RE: Comments on Preliminary Flood Insurance Rate Map and Flood Insurance Study for the City of Ukiah Including the Areas Near Orrs, Gibson, and Doolin Creeks

To	City of Ukiah		
Copy to	GHD Files		
From	GHD and the City of Ukiah	Tel	+1 415 283 4970
Subject	City of Ukiah FEMA Map Revision Review	Project no.	12589077

This memorandum summarizes GHD's and the City of Ukiah's preliminary review of the Mendocino County Map Revision (Orrs, Gibson, Doolin, and Zone AE) Updates, prepared by FEMA Region 9 and presented to the City of Ukiah (the City) in July 2024. This review included the preliminary Flood Insurance Study (FIS) and Flood Insurance Rate Map (FIRM) dated July 10, 2024, and the hydraulic analysis model and data provided by the FEMA's STARR II contractor team on September 11, 2024.

06045C1512G (1 of 11)

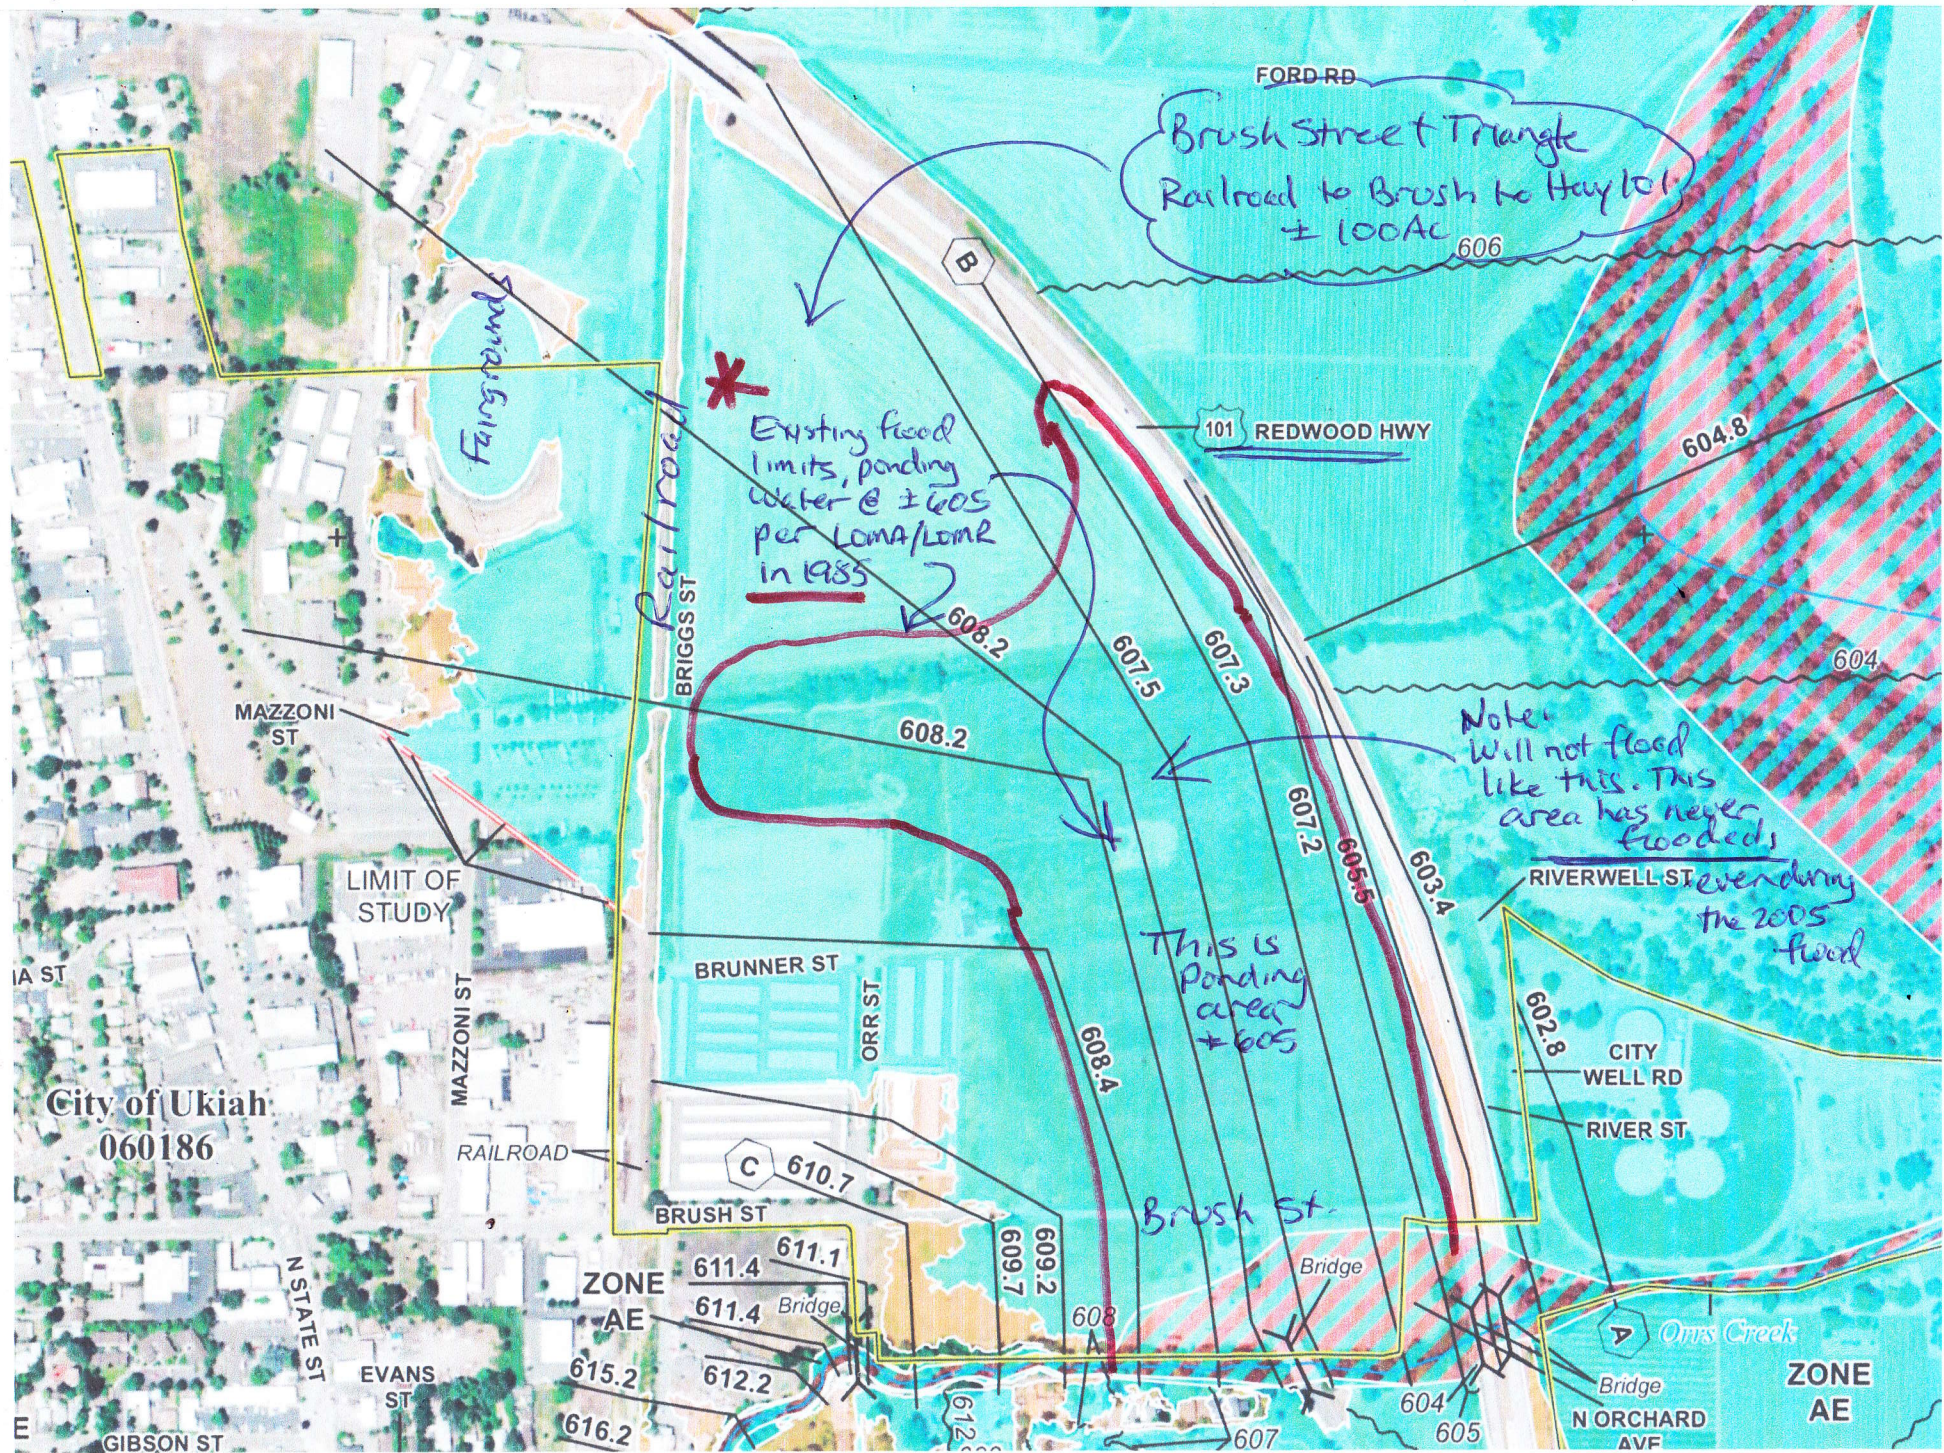
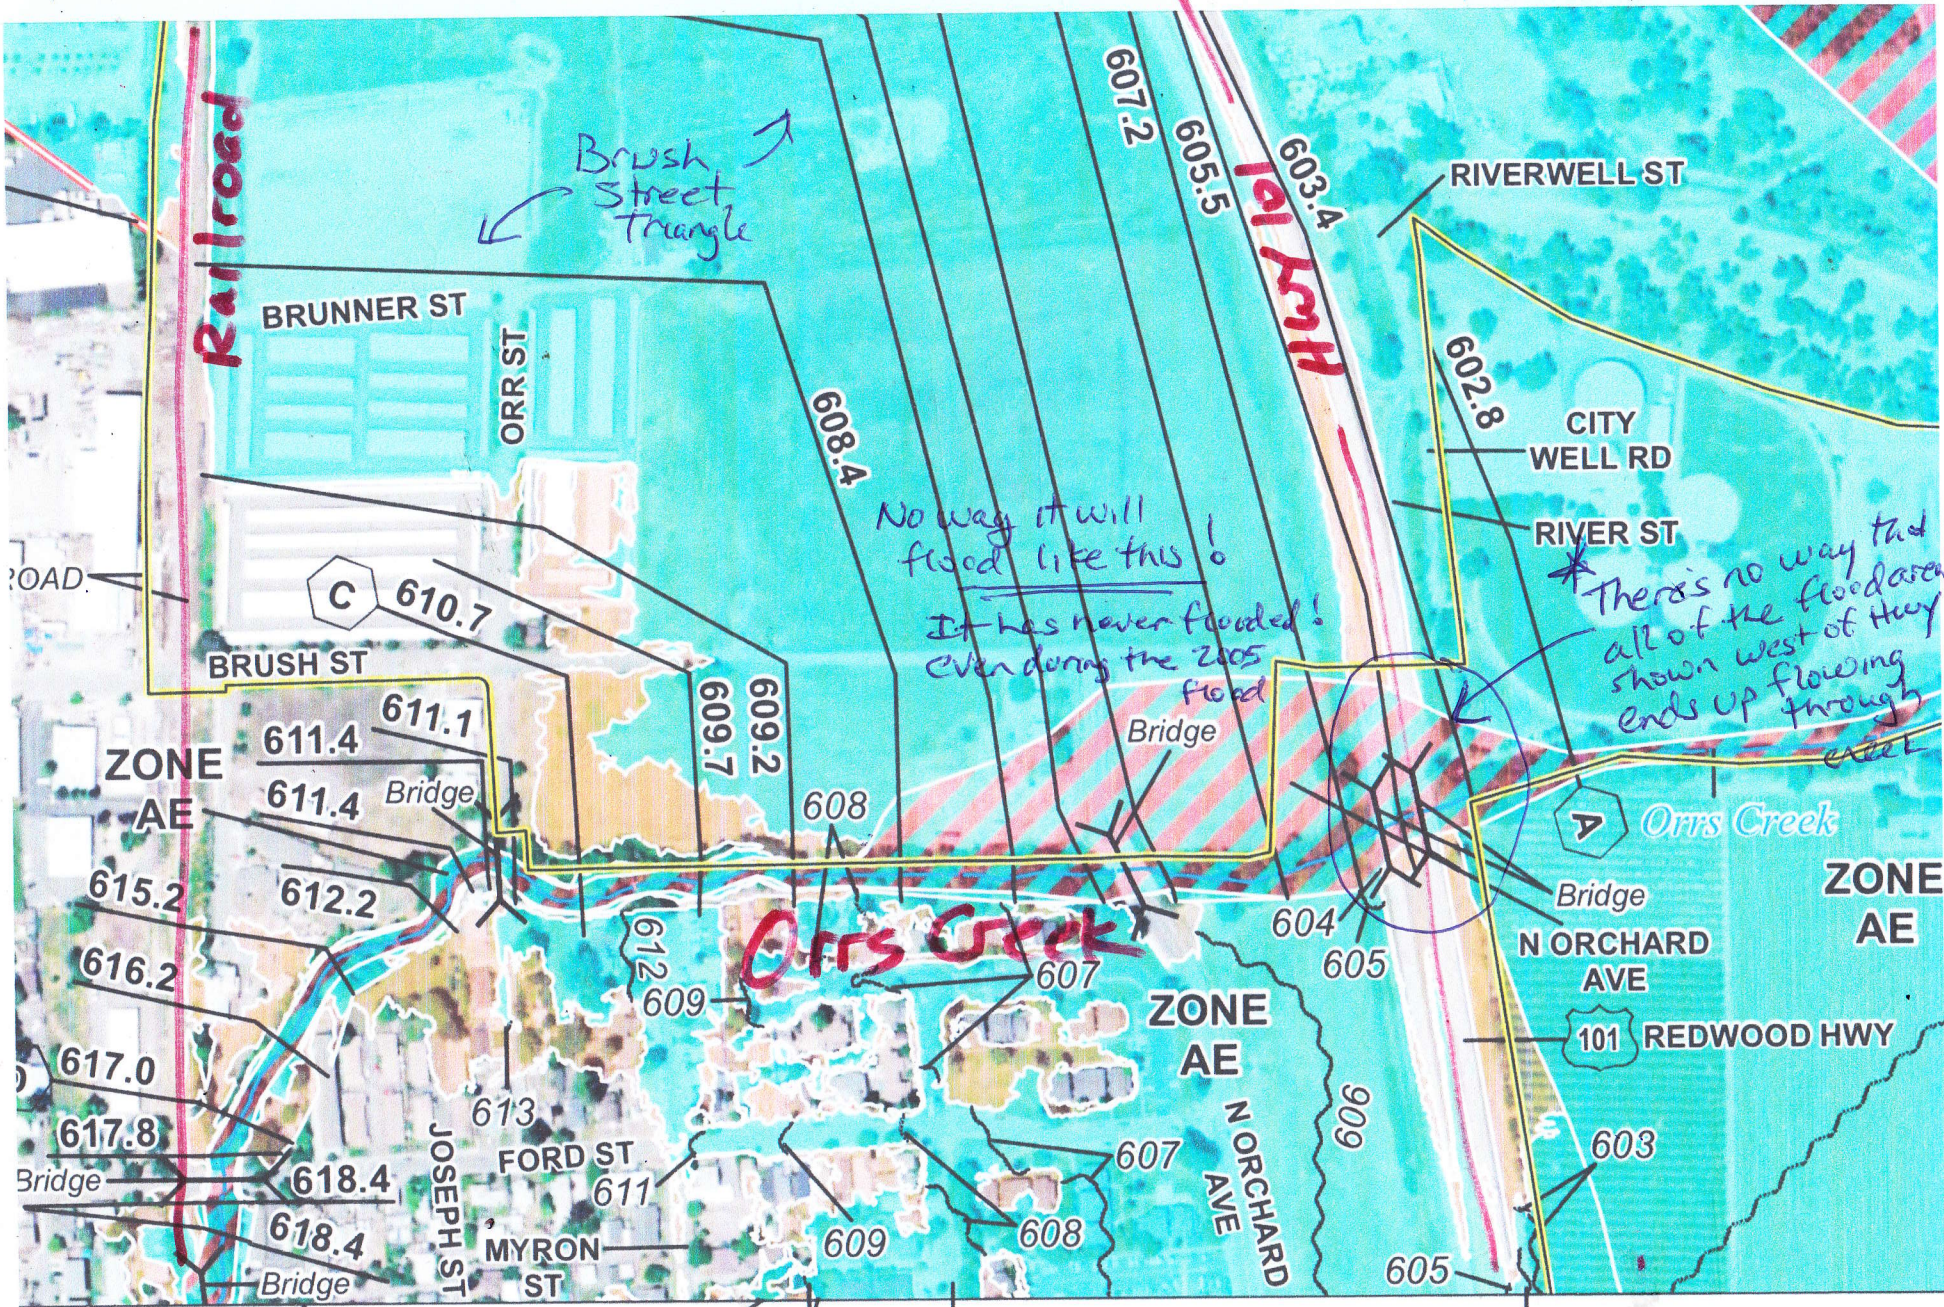
The proposed new flood map for this area shows all of the area north of Orrs Creek flooding with depths 3' or 4' deeper than the existing flood map. It also shows a water surface with fairly steep slopes heading east and generally matching with the water surface slope in the Orrs Creek channel. This is completely impossible. There is no way for flood water to get, over 2000 feet northerly, into this area and then continue flowing easterly at rates of about 8 feet per second and then just stop at the highway. Then once all of this water (probably about 10 times as much as is flowing in the creek channel) somehow just stops at the highway and then magically gets back to the creek channel before it crosses the highway. This will absolutely not happen. If this area floods at all, it will build up about a foot deep at the highway and then cross the highway more than 1000 feet north of Orrs Creek. It will never get back to the creek. Mapping in this area needs to change, flooding will never happen as shown.

06045C1514G (2 of 11)

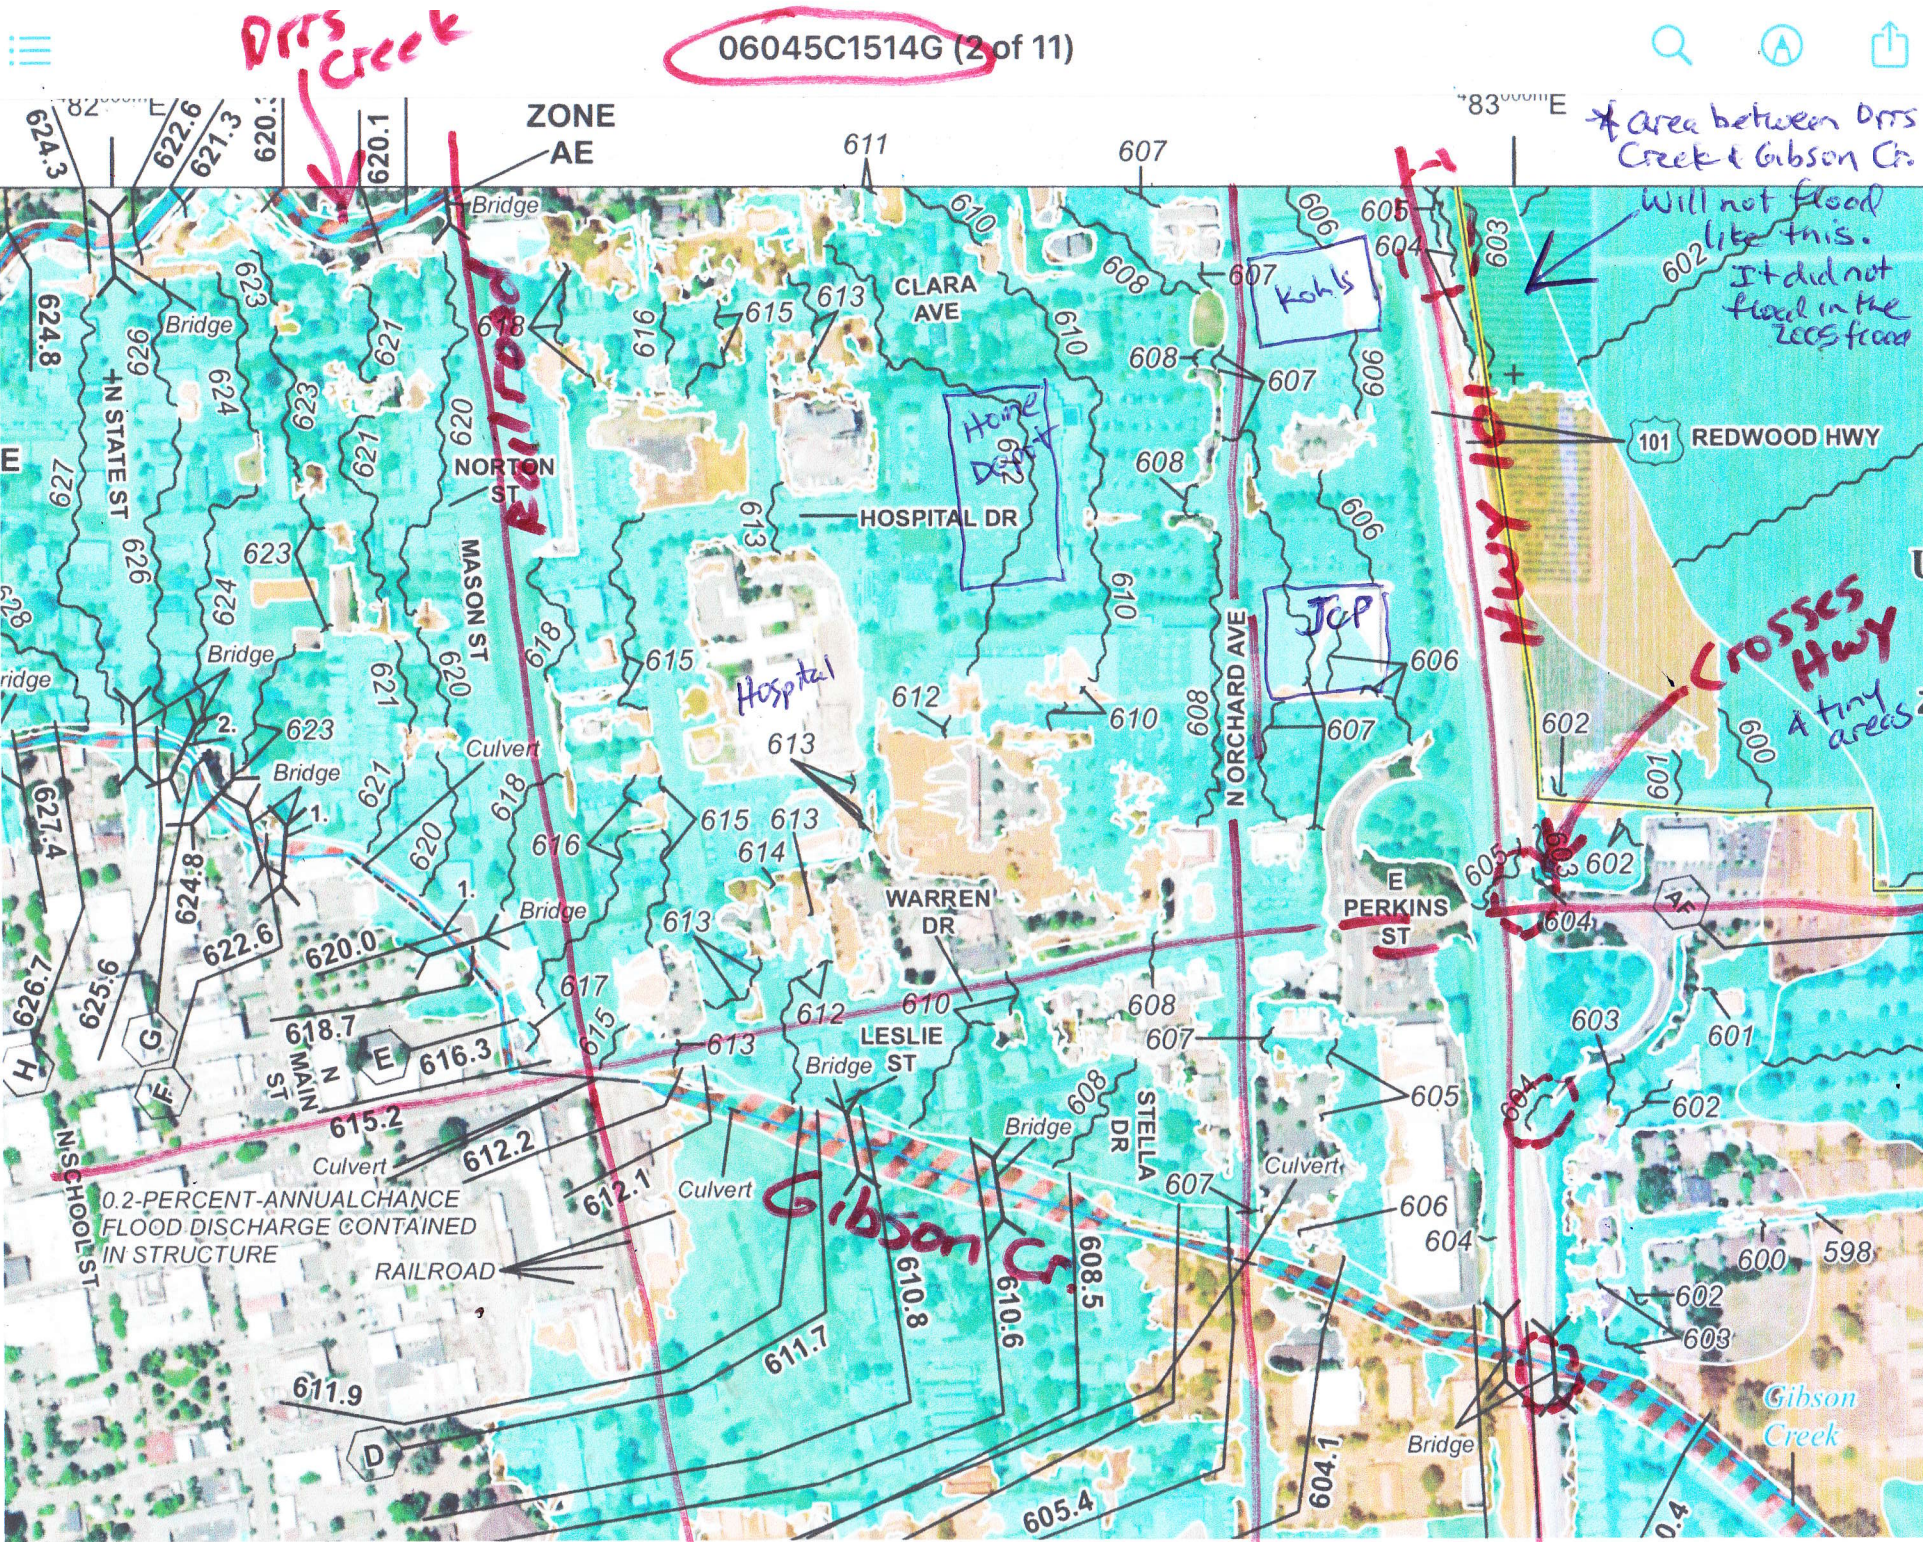
Another general area of concern is the huge area between Orrs Creek and Gibson Creek. This area is mostly residential to the north and west and commercial on the east portion up to Highway 101. None, or very little, of this area is currently in the floodplain. The proposed new map shows all of it being added to the floodplain. The new map also shows a fairly steep water surface which means fairly fast moving water heading east. This massive volume of water then again, just stops at the highway and somehow finds it's way across the highway in 3 or 4 tiny little areas. Again, this is completely impossible. Also, none of this area flooded during the 2005 flood except for minor flooding along the creeks and maybe a little ponding adjacent to the

Doolin Creek is a fairly small creek that flows through mainly residential areas. One area that I question is the large area that is proposed to be added to the floodplain between the railroad and South State Street. The floodplain generally, and accurately, follows along the creek channel in this area. The map shows the same situation where all of this new floodplain area is flowing quickly east and then just stops at the railroad. Then, again, somehow all of this water just goes north and ends up back in the Doolin Creek channel at a very small culvert crossing. This won't happen, if this area were to flood, it will build up a foot at the tracks and will then flow east across the tracks and down Talmage Road.
